ECE/TRANS/WP.29/2009/105  
23 July 2009

**World Forum for Harmonization of Vehicle Regulations**

Proposal for Supplement 9 to Regulation No. 110  
(Specific components for CNG)

"Fig. 2: 20 MPa Filling unit Size 2 (receptacle) for M<sub>2</sub>, M<sub>3</sub>, N<sub>2</sub> and N<sub>3</sub> vehicles

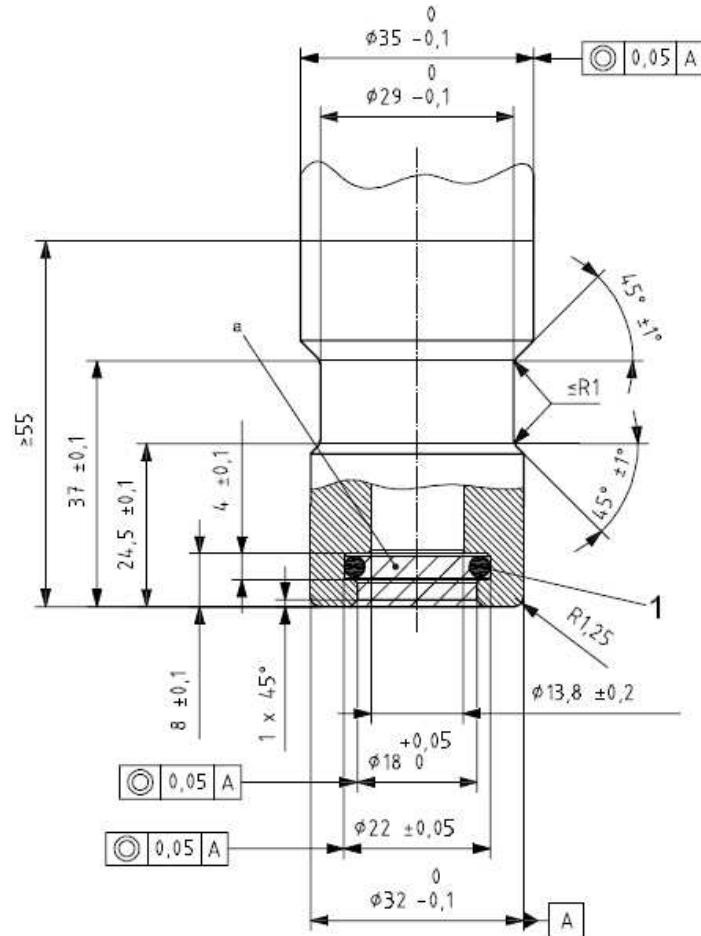
Insert a new paragraph 4.2., to read:

"4.2. Figure 2 shows the dimensions of the filling unit for vehicles of categories M<sub>2</sub>, M<sub>3</sub>, N<sub>2</sub> and N<sub>3</sub>. 3/"

Insert, after Figure1, a new Figure 2, to read:

1 sealing ID =  $\varnothing 15,47 \pm 0,1$  width =  $\varnothing 3,53 \pm 0,2$

<sup>a</sup> This area shall be kept free of all components

Surface roughness < Ra 3,2 µm.

Sealing surface finish: 0,8 µm to 0,05 µm.

Material hardness: 75 Rockwell B (HRB 75) minimum.
